PROJECT: BLM Site II - Update for Onsite Residential Development

SUBMITTAL: 4th Submittal

CITY OF LAS VEGAS		DATE:
INTER-OFFICE MEMORANDUM		September 21, 2016
TO: Land Development Services Department of Building & Safety		FROM: Albert Sung, P.E. Flood Control Project Engineer Department of Public Works
SUBJECT:	Drainage Study for:	
	BLM Site 11 – Update for Onsite Residential Development	
Cross Streets:	SWC of Tropical Pkwy & Michelli Crest Way	
File Number:	F:\Depot\DSMemos\DS4789D.doc	
Parcel Number:	126-25-701-001	
Zoning Action:	ZON-62343; VAR-63098; WVR-63099; TMP-63100 & VAR-63259	
FEMA Flood Zone	YES	NO X
Proposed Storm Drain	YES	NO X
		COPIES TO: Triton Engineering DR Horton Inc. Bart Anderson, P.E., DevCo CCPW

FIGURE 4

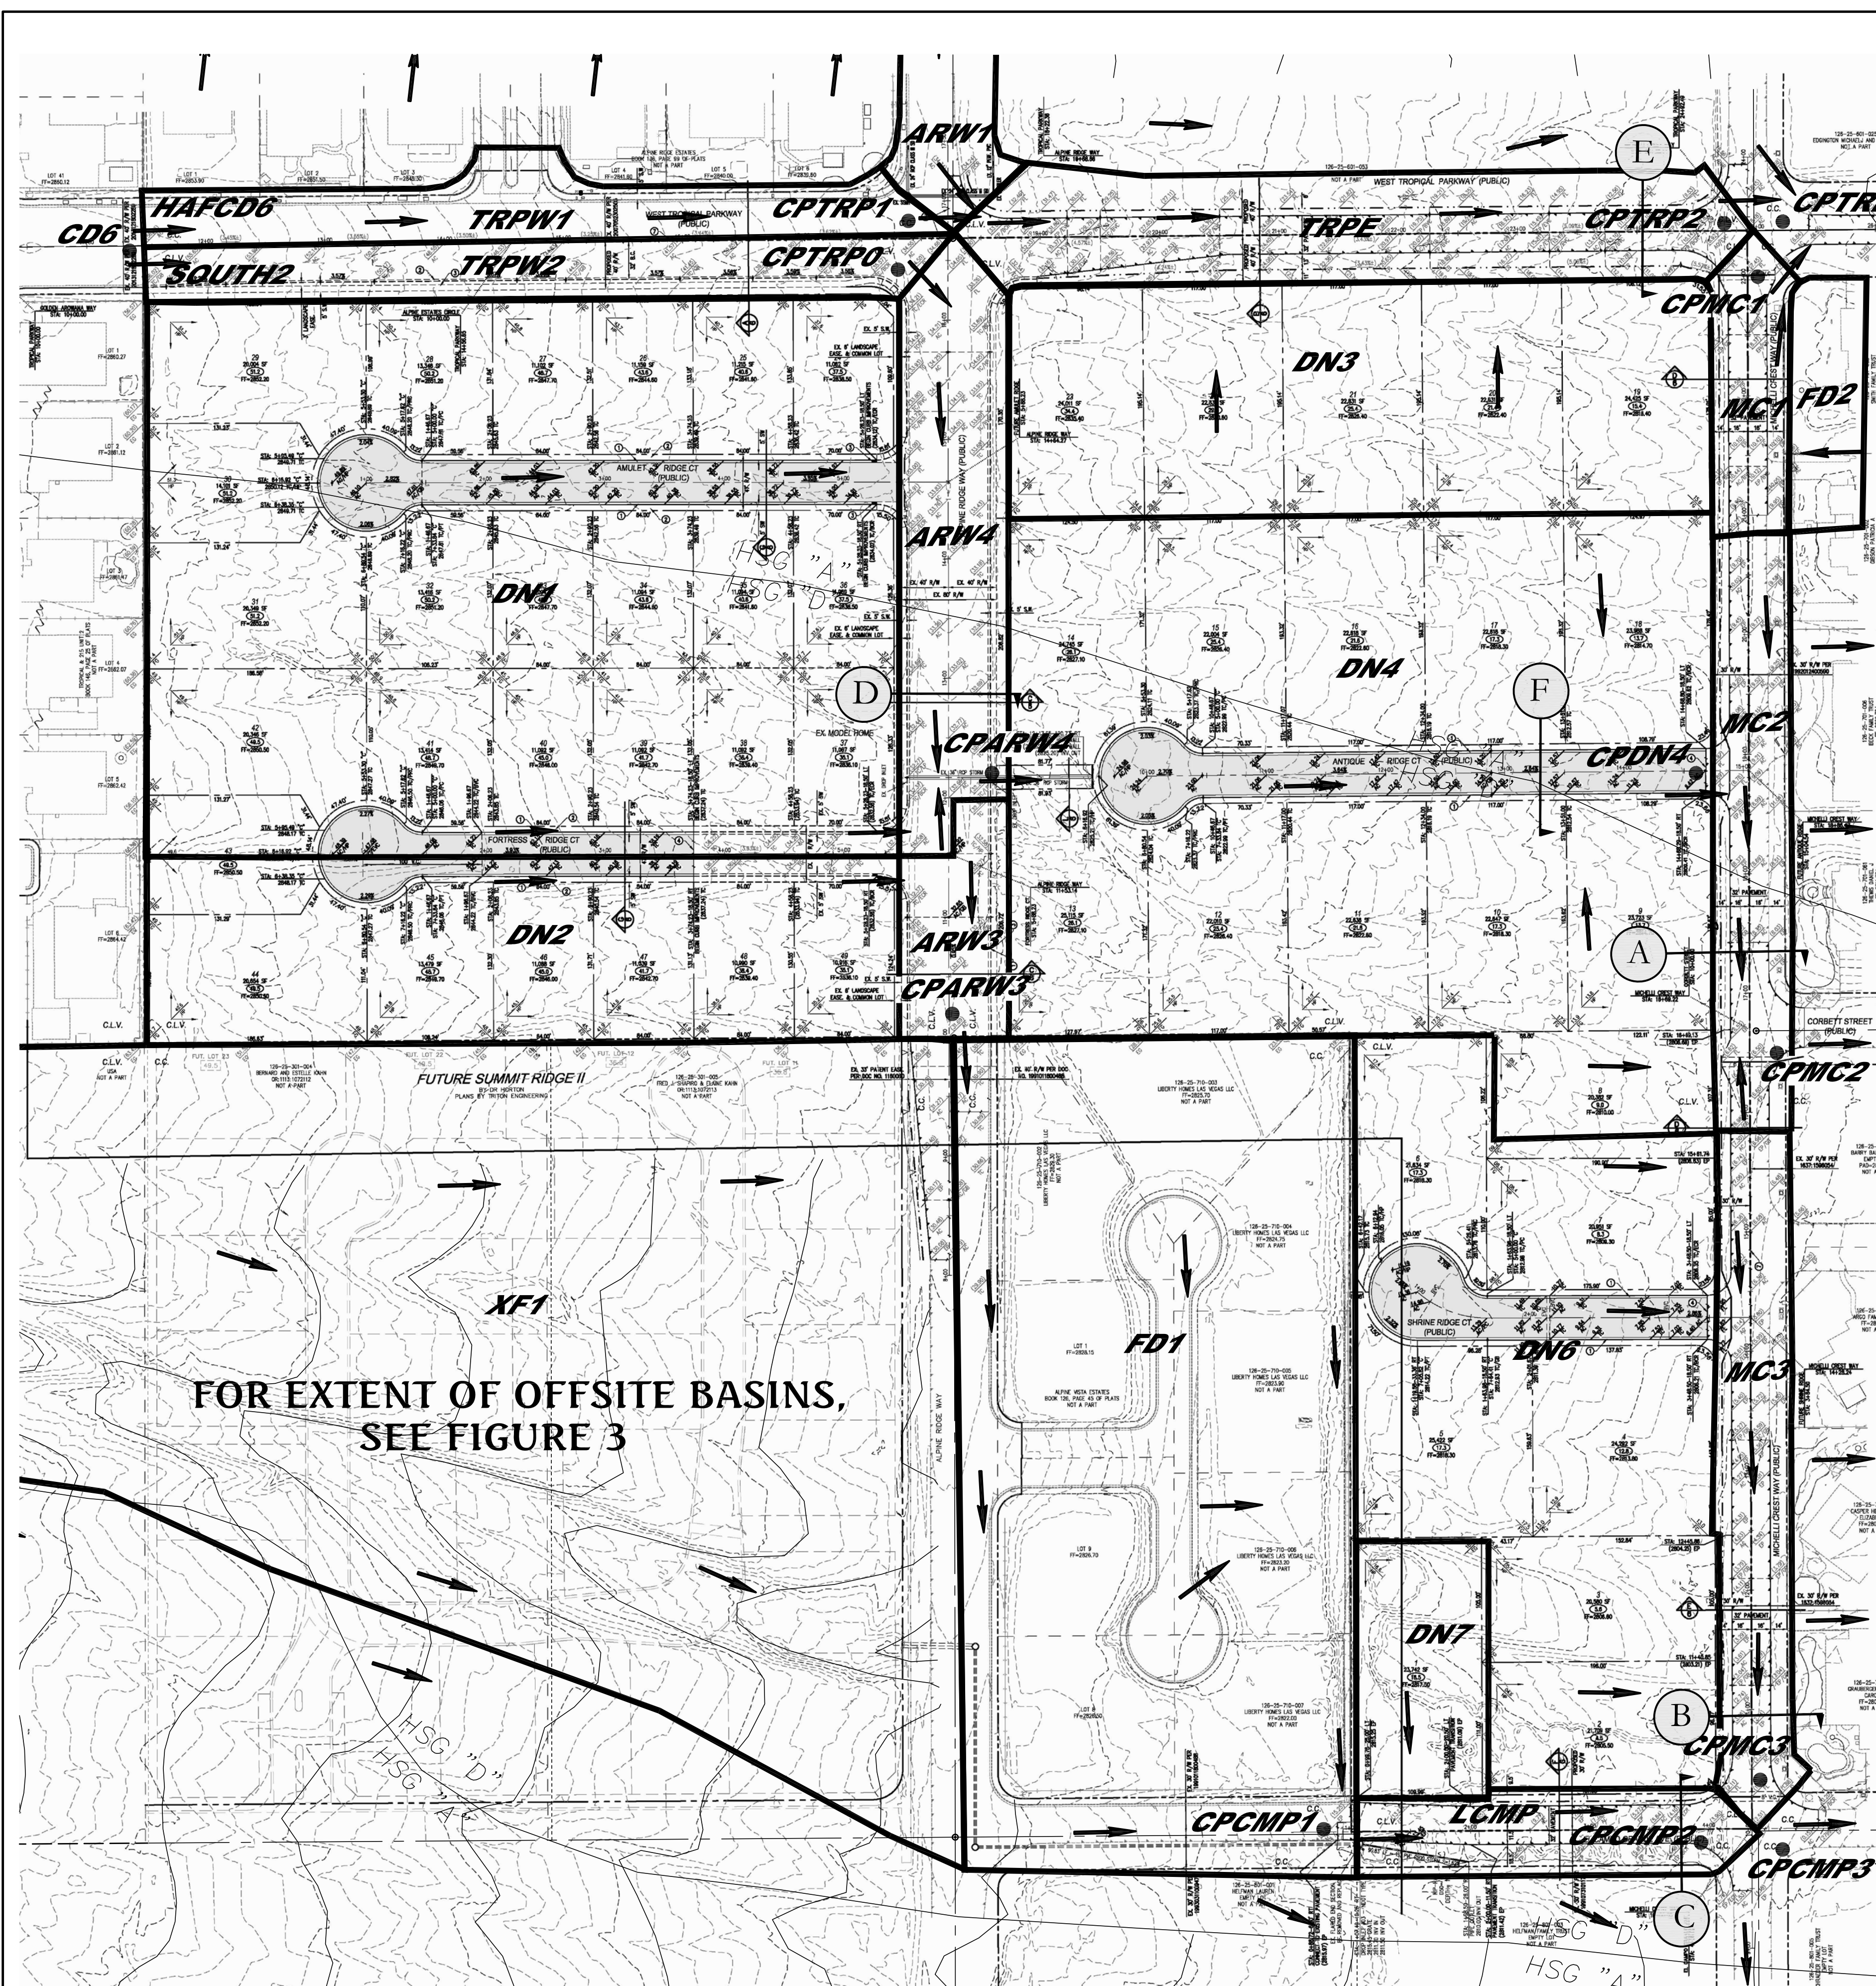
2. **Figure 4 (Developed Conditions Drainage Map):** Is subbasin "DN5" being deliberately eliminated from the plan and the "**Summary of Peak Flow Rates**" Table or merely missing on the drainage map? Address and revise accordingly in the next submittal.

DR. HORTON
BLM SITE 11
ON-SITE DRAINAGE PLANS
GRADING PLAN 1

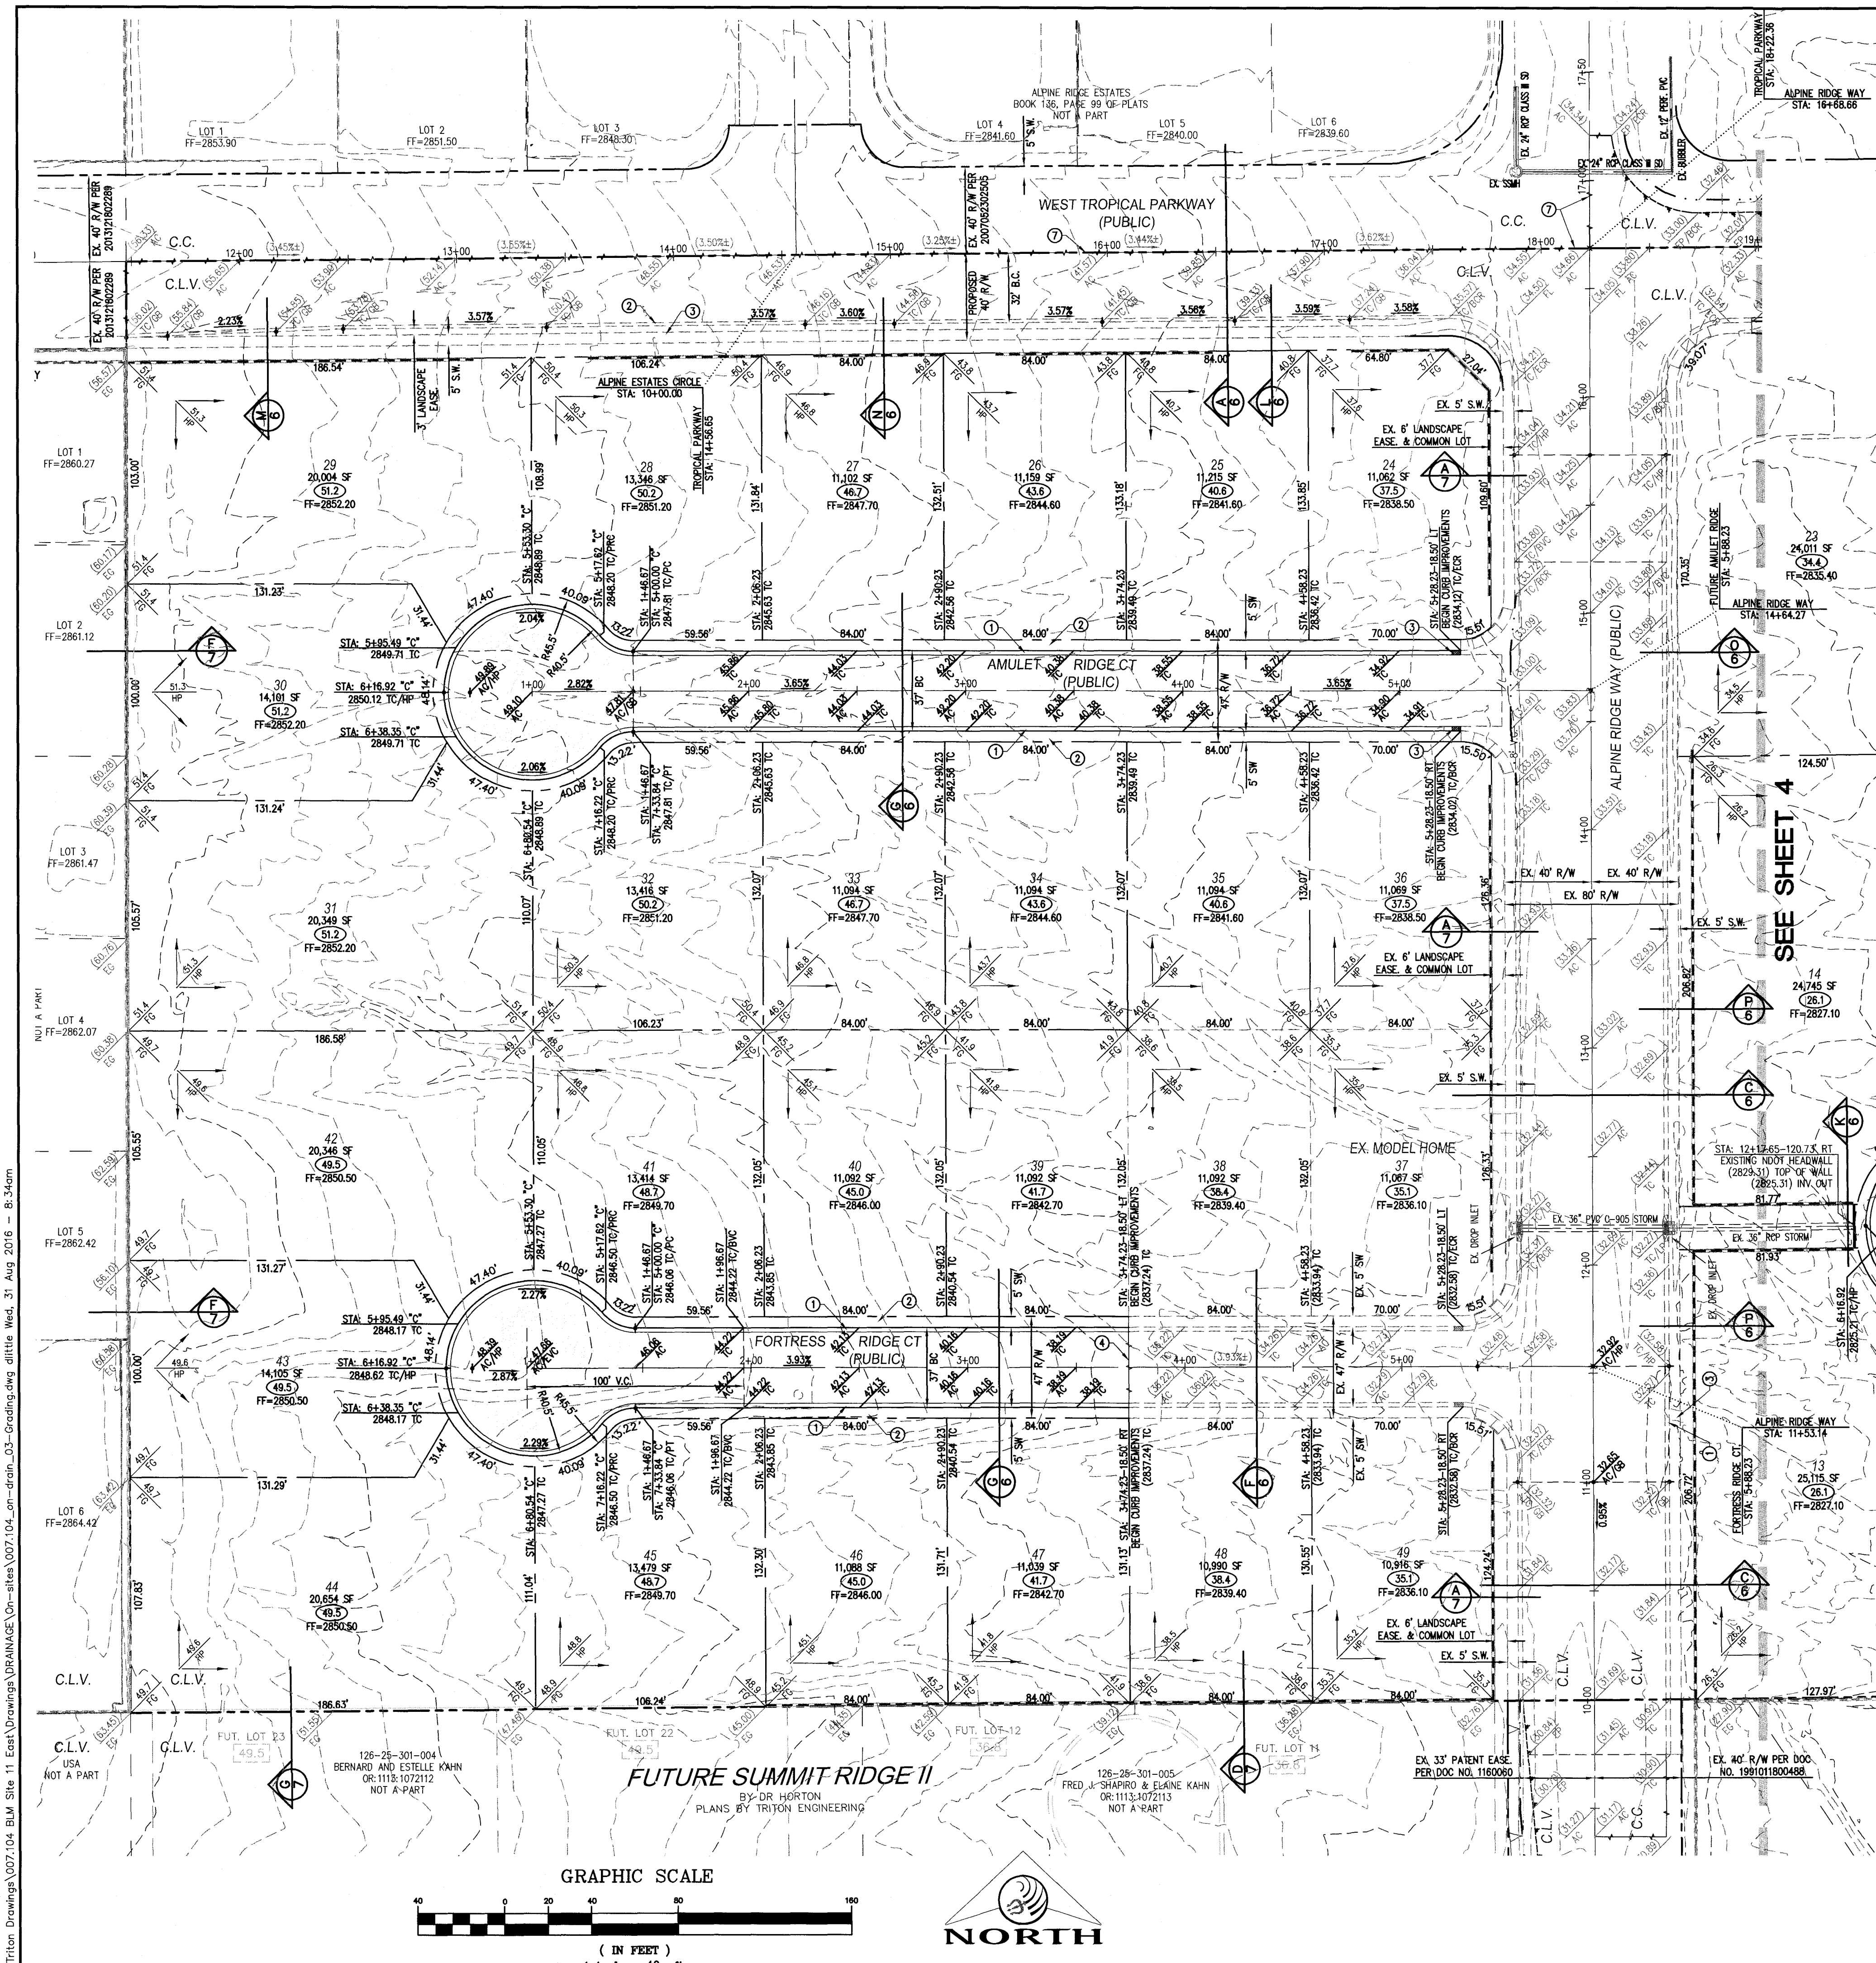
5. Identify the easement between Lot 13 and Lot 14 as 20'-public drainage easement and common lot to be privately maintained by the Homeowners Association on *Grading Plan I* (Sheet 3) and *Grading Plan II* (Sheet 4).
